TITLE
7 x 1 SWITCHING MATRIX

SUB TITLE
COLUMN MEMORY & AUDIO SWITCH, CIRCUIT DRG.

ORIGIN	DATE
DRAWN	
CHEK	
APPC	
A2	9926

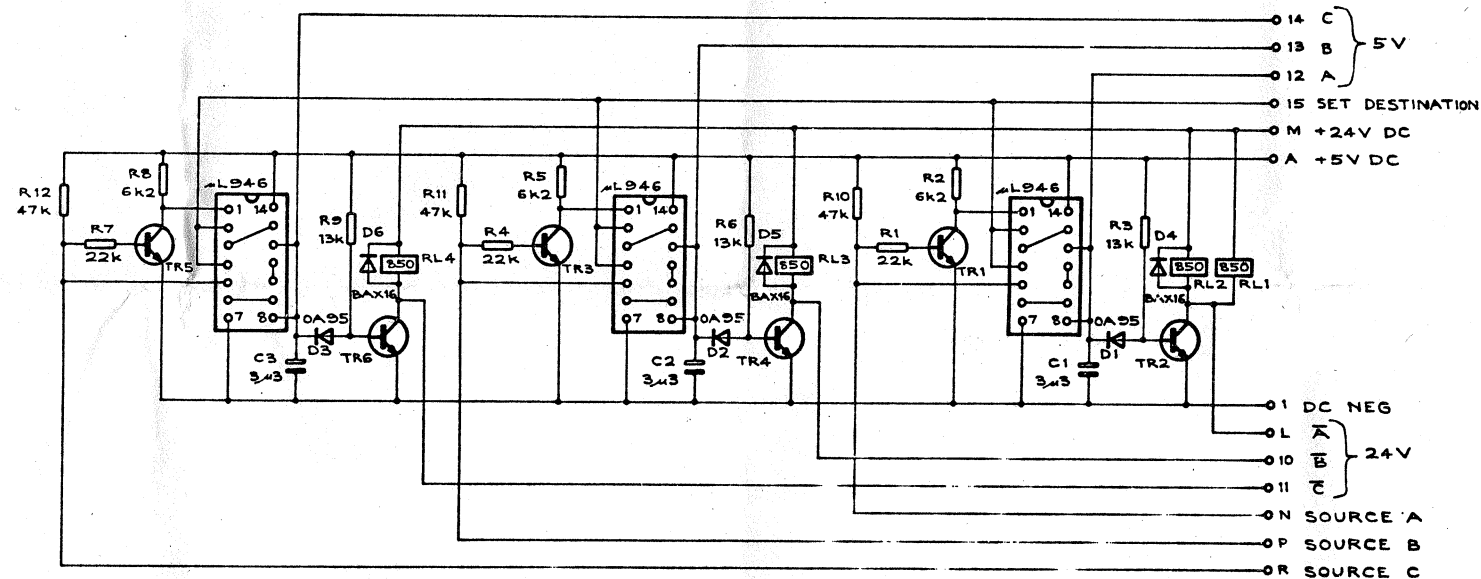
DELETE C1-3

R2, 5, 8

now

680 ohm
